**TOWN OF BROOKLYN**  
**PLANNING AND ZONING COMMISSION**  
**Regular Meeting Agenda**  
**Tuesday, September 15, 2020**  
**6:30 p.m.**

## **ENGINEERING PLAN REVIEW PERTAINING TO PROPOSED PARKING EXPANSION VACHON CHEVROLET (ASSESSOR'S MAP 41, LOTS 13A & 14) PROVIDENCE ROAD (ROUTE 6) BROOKLYN, CT (March 20, 2020)**

The comments contained herein pertain to my review of plans for a 3-lot residential subdivision on Church Street in Brooklyn, Connecticut, consisting of five (5) sheets, prepared for David P. Bell and Nancy M. Bell by PC Survey Associates, LLC and Killingly Engineering Associates, dated April 2020 with revision date of July 6, 2020 (Sheets 1-4). My comments are as follows:

IMPROVEMENT LOCATION SURVEY  
SITE DEVELOPMENT PLAN No. 1  
PREPARED FOR  
**VACHON BROOKLYN, LLC**  
512 PROVIDENCE ROAD (ROUTE 6)  
BROOKLYN, CONNECTICUT

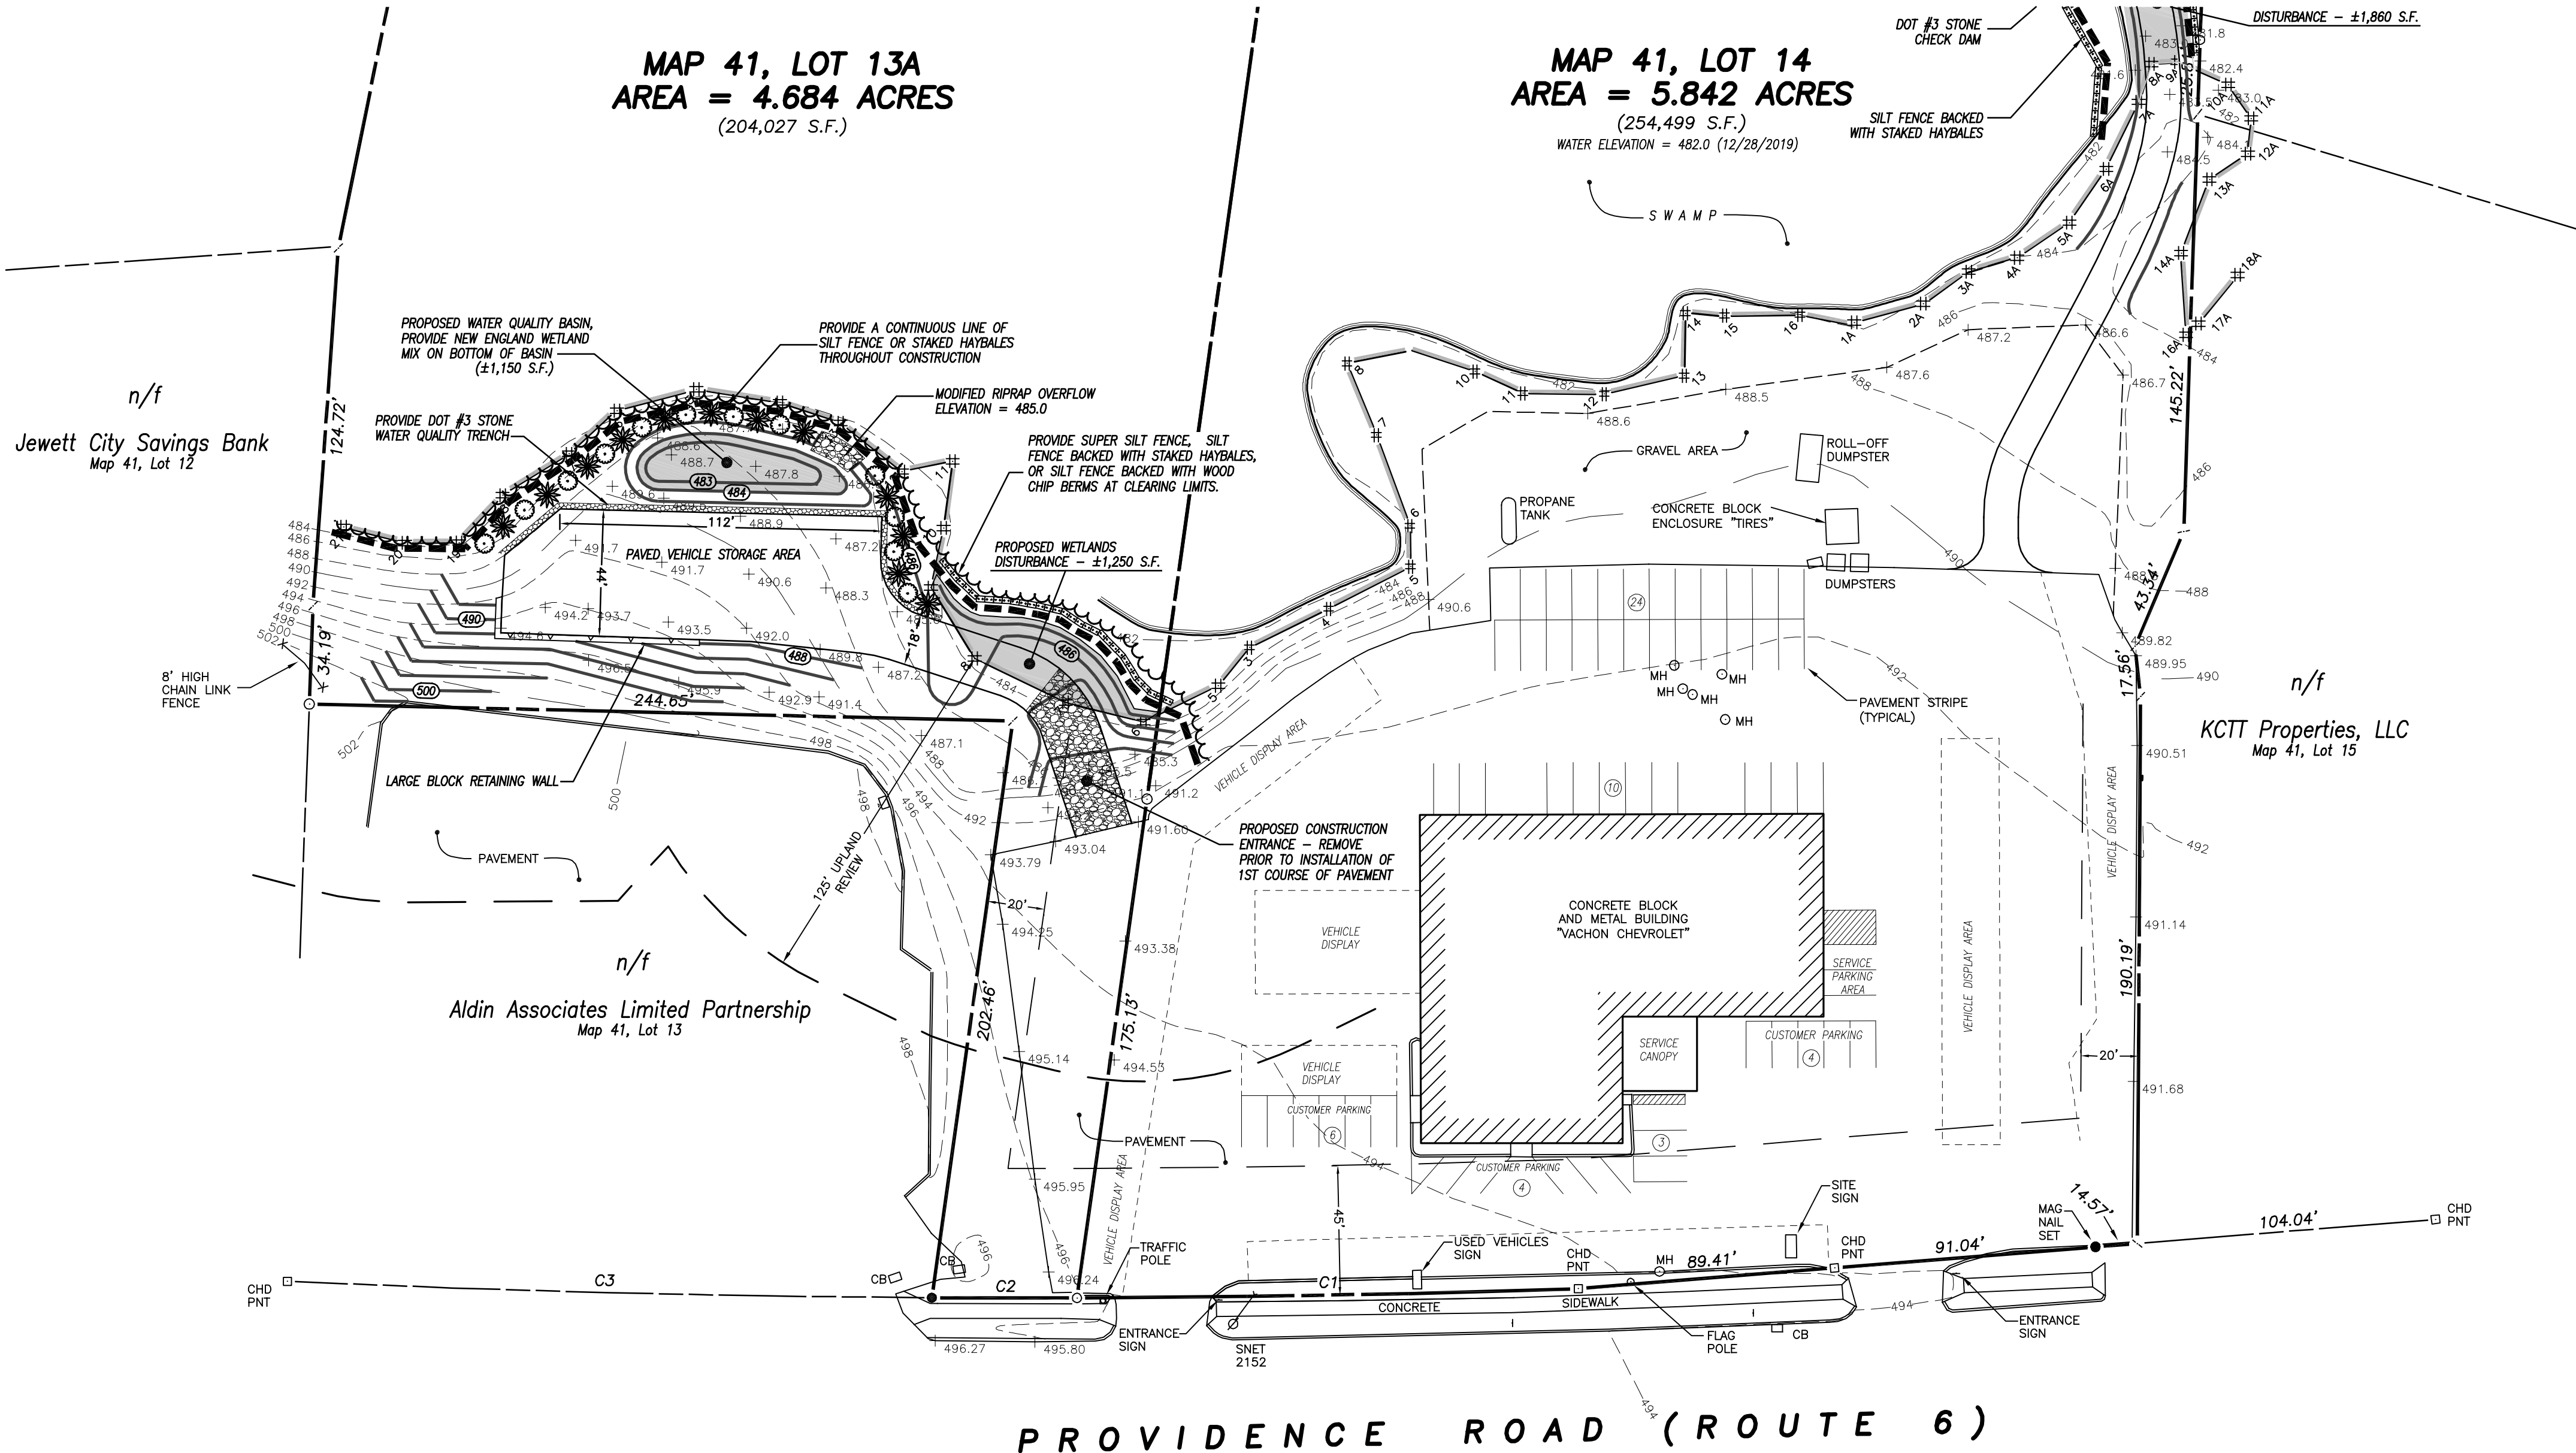
### **SHEET 3 OF 5 – SITE DEVELOPMENT PLAN No. 1**

1. A construction entrance symbol is drawn at the entrance to the new "paved vehicle storage area." However, a note should be included to indicate that this will be removed at the time the first course of paving is installed for the vehicle storage area. Additionally, it would be helpful for this explanation to be included in Note 17 under "Development Schedule/Sequence of Operations" that appears on Sheet 5 of 5 of the plan set.
2. The note "Silt Fence Backed with Staked Haybales or Wood Chip Berms" should read the same as the note on Sheet 4 of 5, "Provide Super Silt Fence, Silt Fence Backed with Staked Haybales, or Silt Fence Backed with Wood Chip Berms at Clearing Limits," for consistency.

### **Sheet 3 of 5 – Site Development Plan No. 1**

1. A note has been added to the plan to direct the contractor to remove the anti-tracking construction entrance prior to installing the first course of pavement. This has also been noted on sheet 5 of 5 in the development schedule/sequence of operations.
2. The note "silt fence backed with staked haybales or wood chip berms" has been modified to read the same on all sheets.

DATE: 1/07/2020	DRAWN: AMR
SCALE: NOT TO SCALE	DESIGN: NET
SHEET: 5 OF 5	CHK BY: ---
DWG. NO: CLIENT FILE	JOB No: 19129

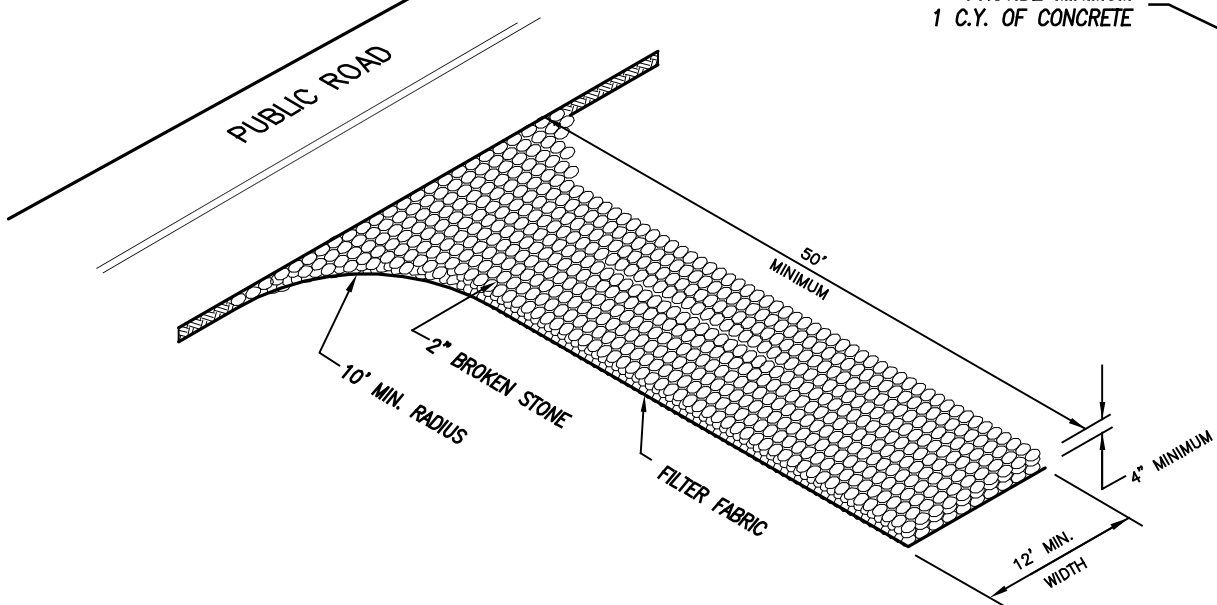
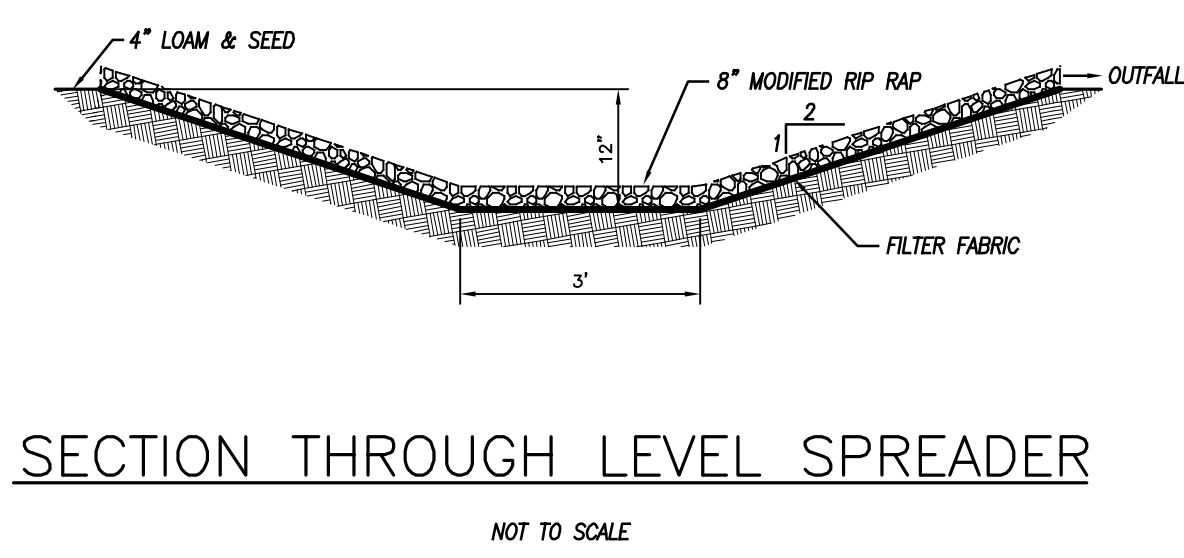
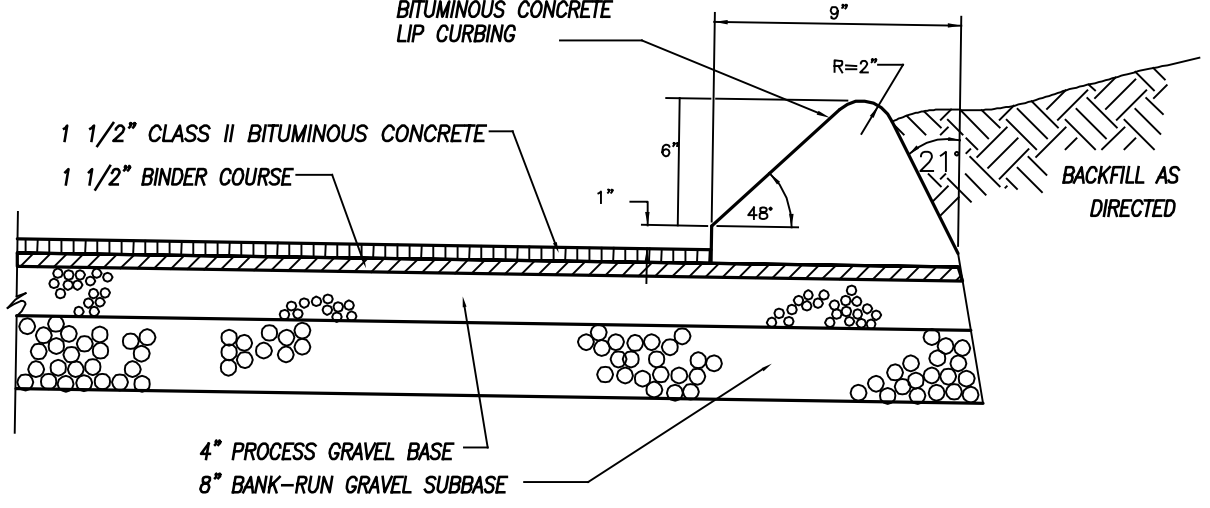
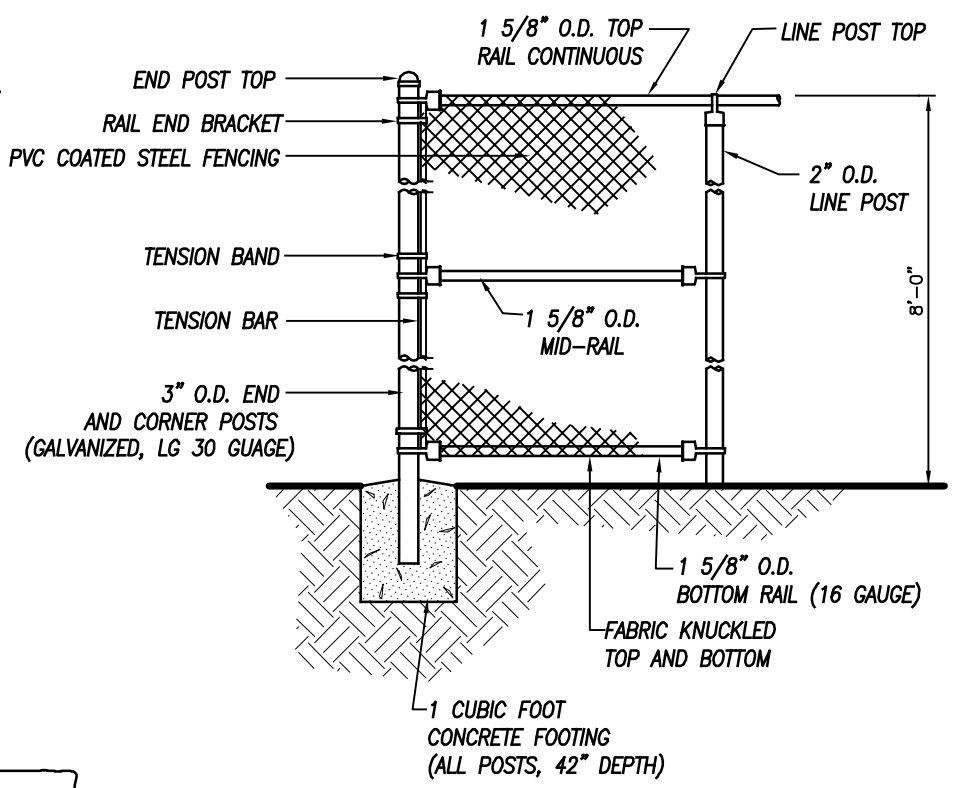
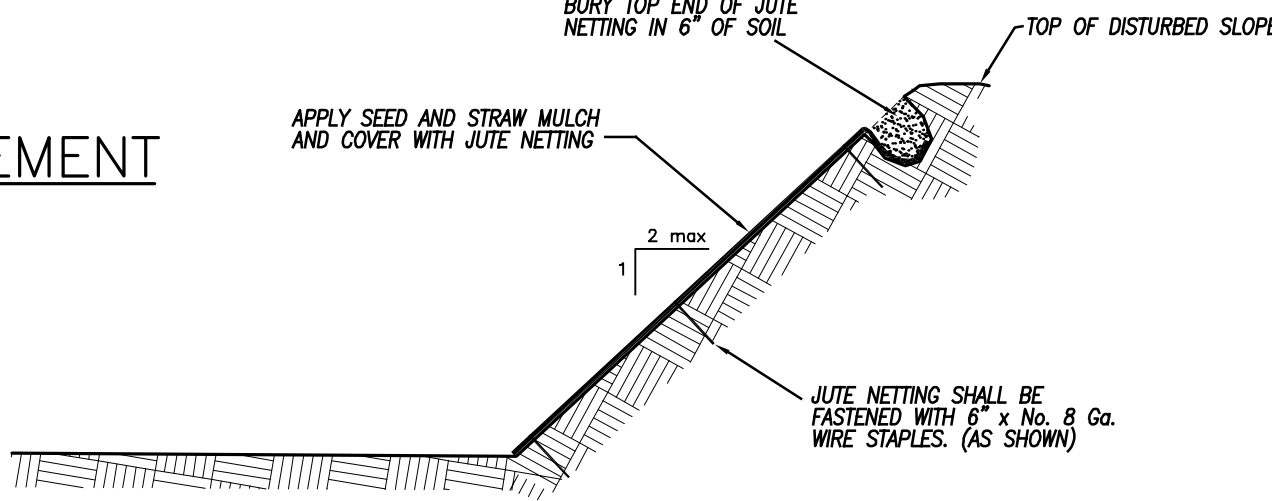
#### **SHEET 5 OF 5 – DETAIL SHEET**

**Sheet 5 of 5 – Detail Sheet**

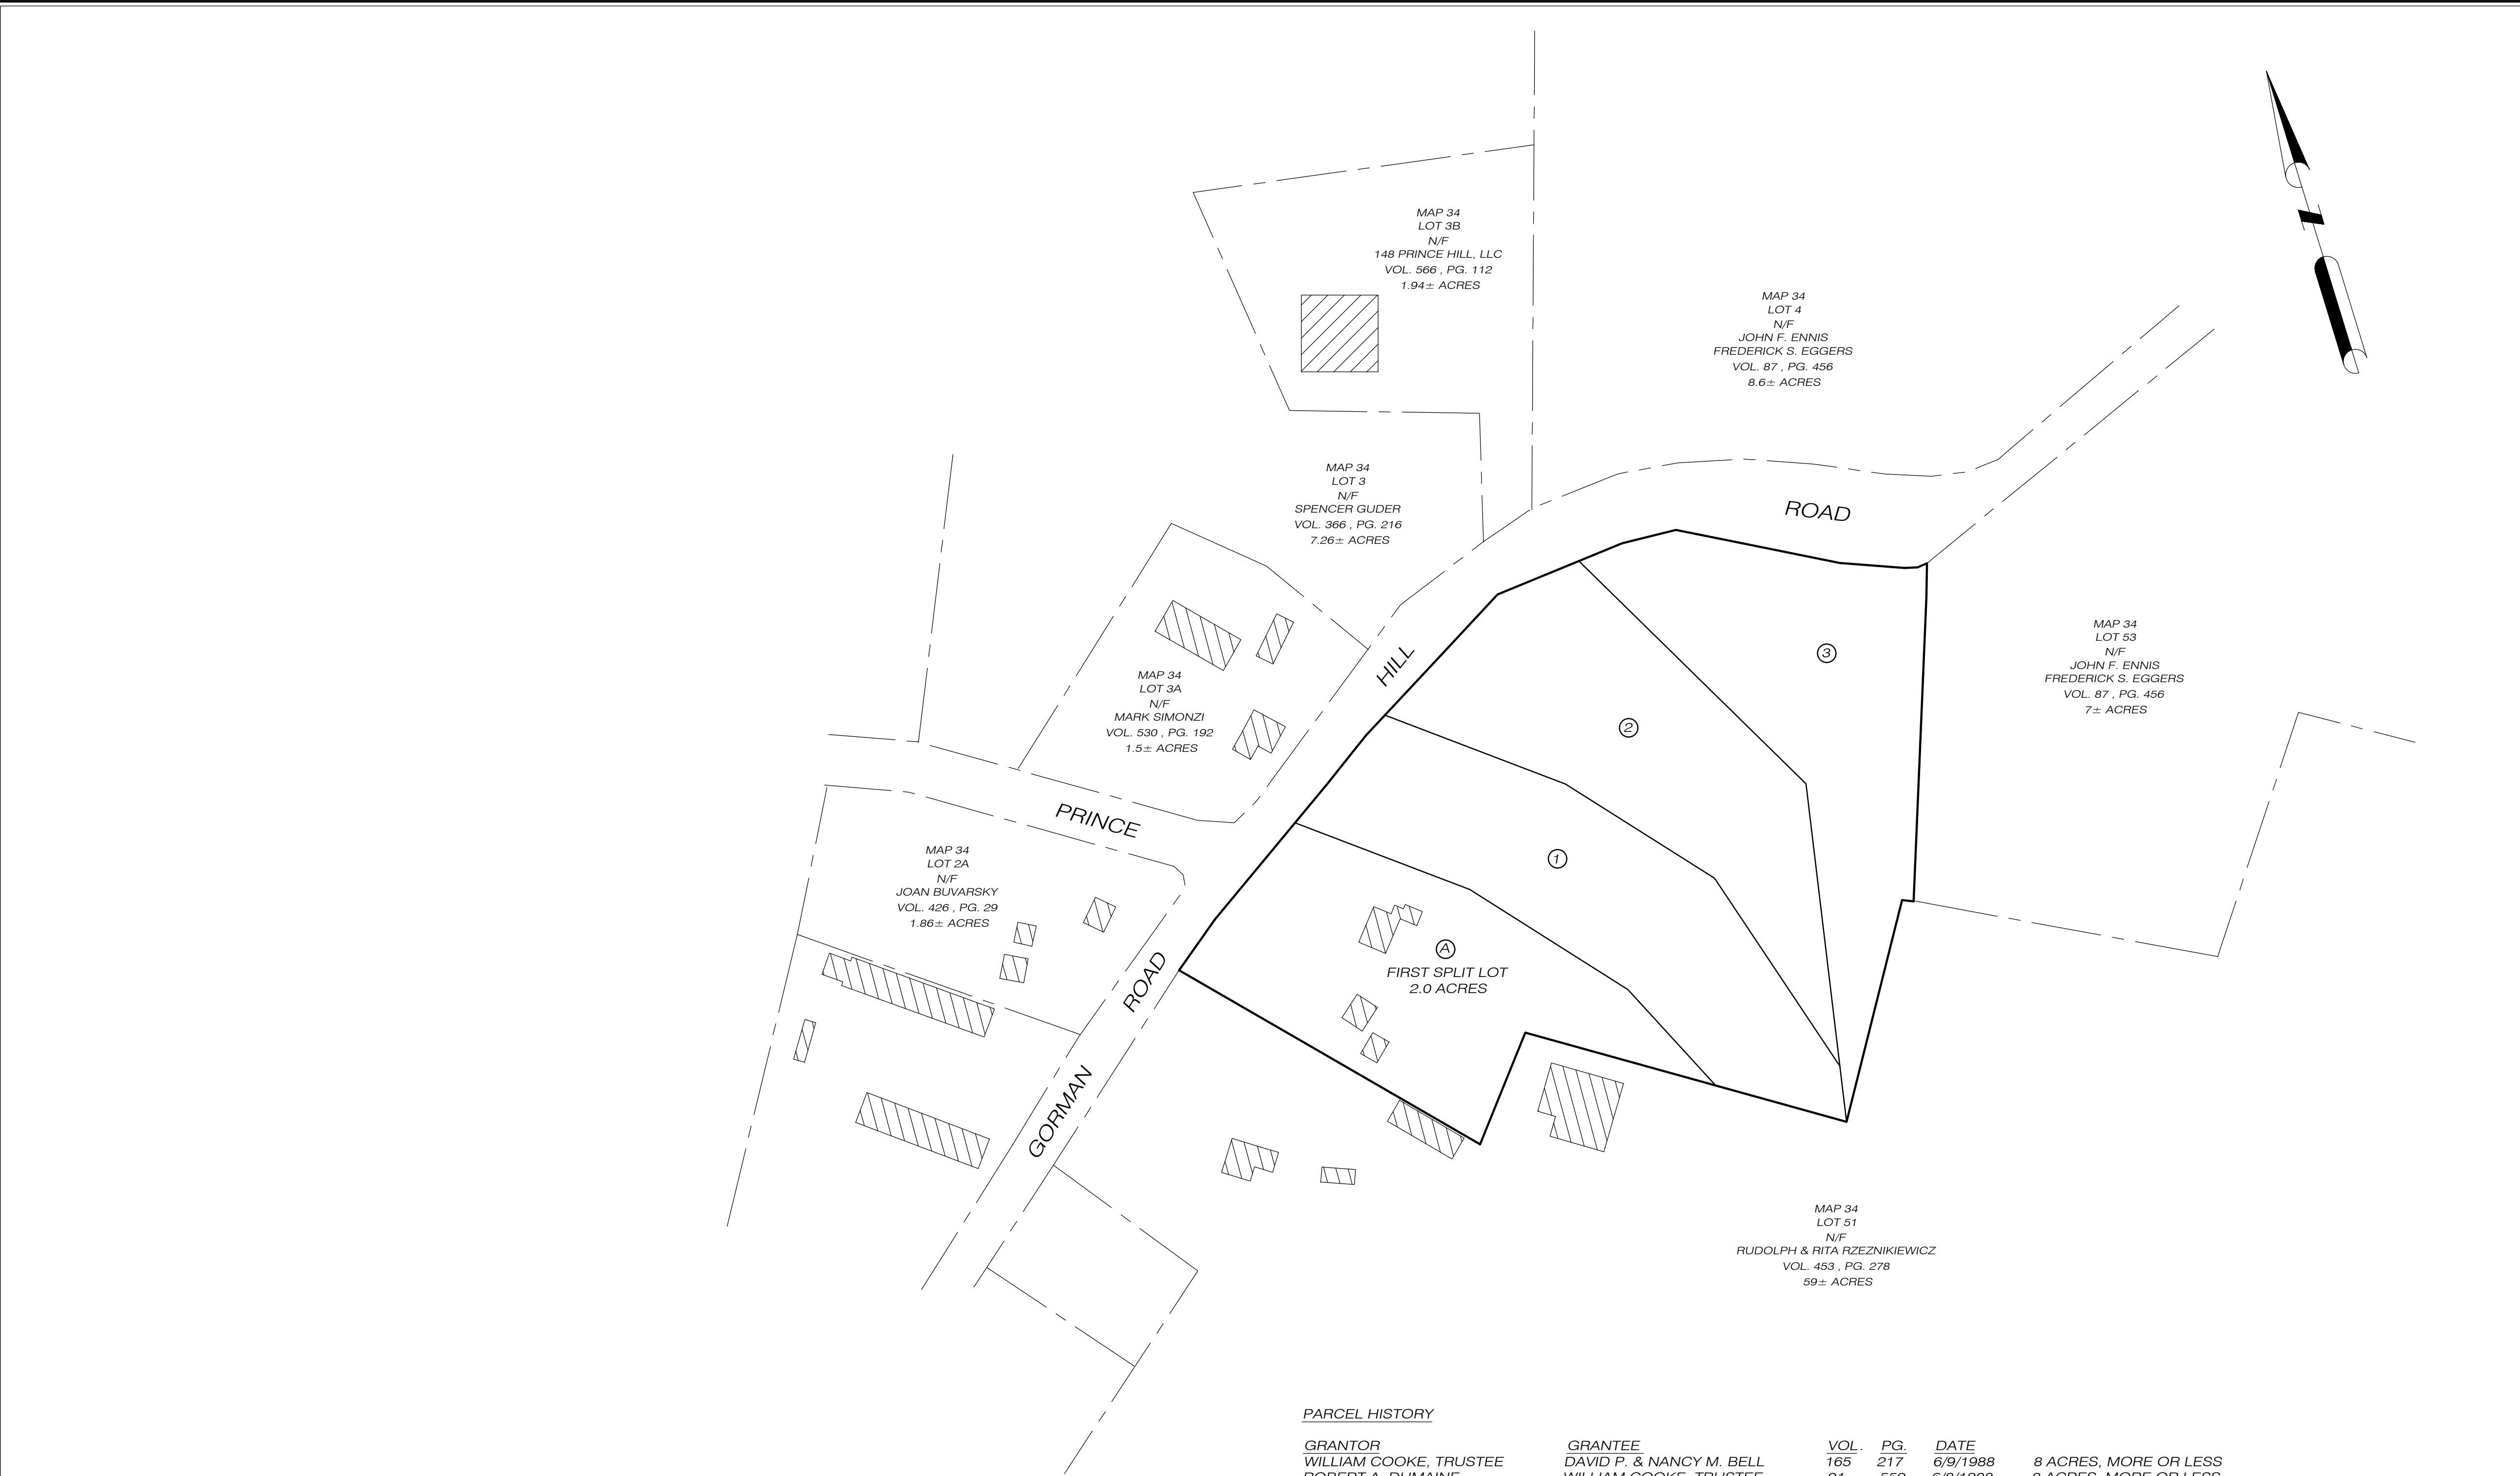
1. The Conservation Easement shown on previous plan submissions has been removed. A note on Sheet 2 of 4 of the most recent plans states that the Applicant shall pay an Open Space Fee in lieu of adding further protection to the wetland with a Conservation Easement.

2. The Sight Line Easement shown on previous plan submissions on the Subdivision Plan, Sheet 2 of 4, has been eliminated. It is my opinion that the easement is required and should be redrawn on this plan sheet and on the Lot Development Plan, Sheet 3 of 4. Incidentally, proposed grading is shown on Sheet 3 of 4 to provide a good sight line to the east for a vehicle exiting the driveway of Lot 2 and motorists traveling eastbound on Prince Hill Road.
